**STAFF REPORT
KETCHUM PLANNING AND ZONING COMMISSION
REGULAR MEETING OF JANUARY 13, 2020**

PROJECT: Swan Geogrid

FILE NUMBER: P19-138

REQUEST: Floodplain development application for installation of a geogrid within the floodplain

Figure 2. Area of proposed geogrid installation

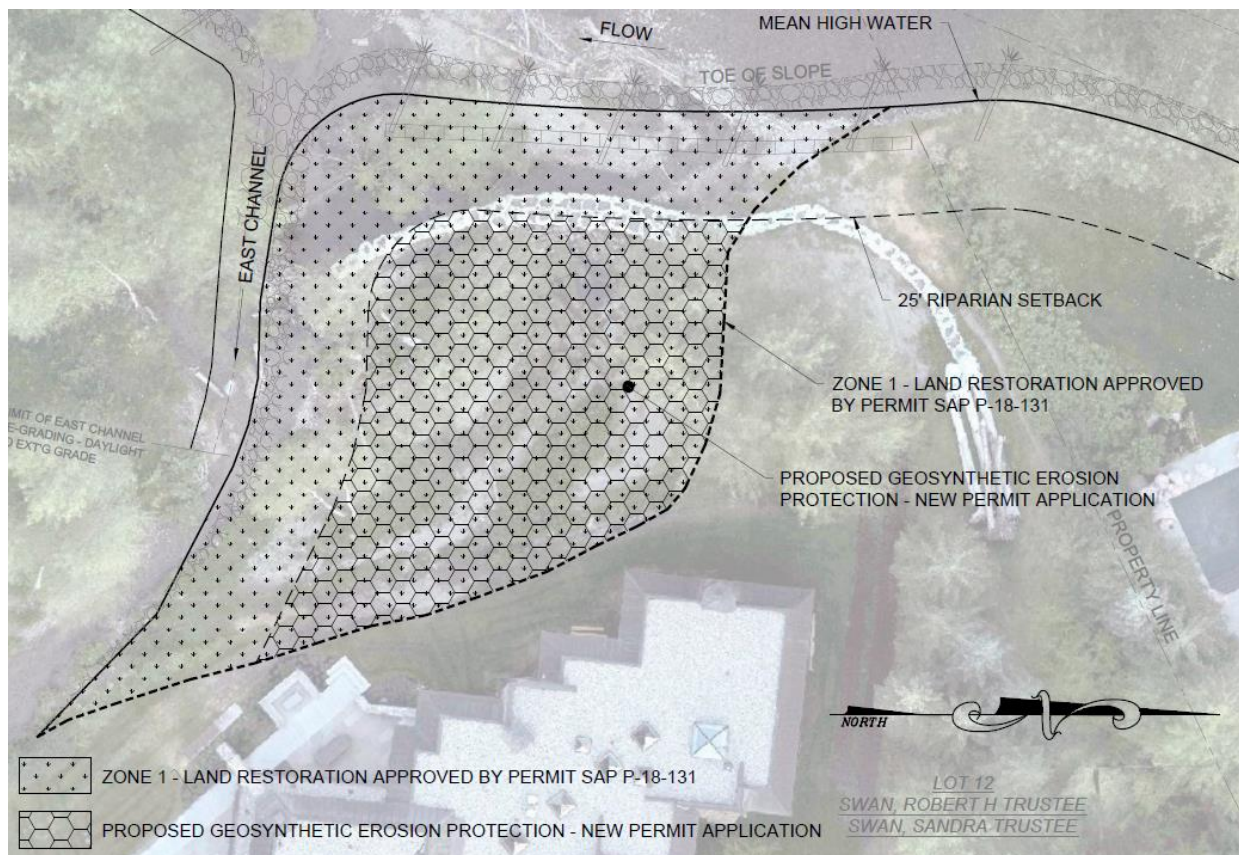
The request before the Commission is for installation of the geogrid, as specified in the Brockway Engineering memo dated November 14, 2019 and the plan drawings dated November 14, 2019 (attachment B) in a land area approximately 7,023 square feet in size.

If the application is denied the approvals granted with P18-131 remain in effect. However, the applicant is not required to plant only the 3 shrubs per 1,000 square feet and the 5 cottonwood seedlings. Staff supports a modification to the proposal to change the groundcover (grass mix) to a riparian grass mix and to increase planting density in order to mitigate the risk of erosion during a future flood event.

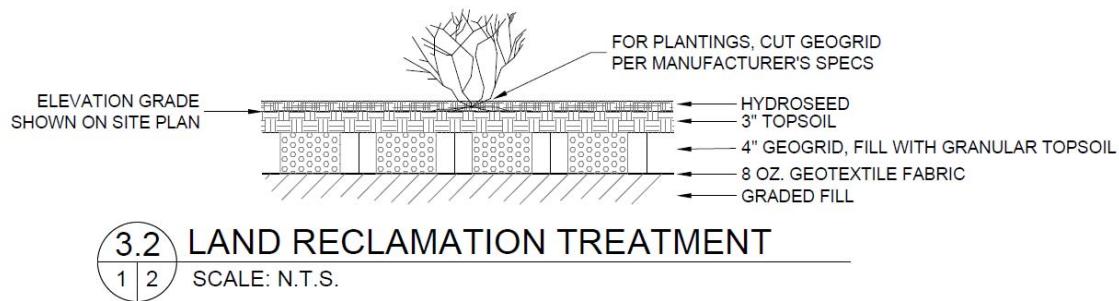
The schematic below shows the Envirogrid product installation. The product is placed on a graded sub-base and separated from the sub-base by a geotextile fabric. This fabric is similar to a weed mat, but thicker. Separation between the sub-base is needed to prevent mixing of the native material and granular fill material within the cells and potentially destabilizing the base. The Envirogrid is then filled with granular material comprised of sandy loam or gravelly sandy loam, followed by a layer of topsoil. Vegetative treatments within the Zone 1 restoration area have already been approved in SAP P18-131 and consist of grasses as well as riparian shrub plantings. Shrub plantings are made within each cell of the Envirogrid, or if necessary the cell walls can be cut to allow larger plant to be made.

City staff has expressed some concerns regarding the efficacy of the geogrid, each of which is addressed as follows.

The geogrid may dislodge and end up in the river. The product is a continuous blanket, filled with granular material and topped with soil. It is not possible for water to erode below the top of the geogrid. Installation of the product includes staking it into the ground. Vegetation will be planted in and amongst the cells, providing a root structure to act as a further anchor to the product. The product does not float. For the product to end up in the river, all of these structural measures would have to be overpowered, and the river would have to slide the entire layer of geogrid as a unit into the river. Even if such sliding were to occur, it would not be toward the river because there is no gradient in that direction, either topographically or hydraulically.
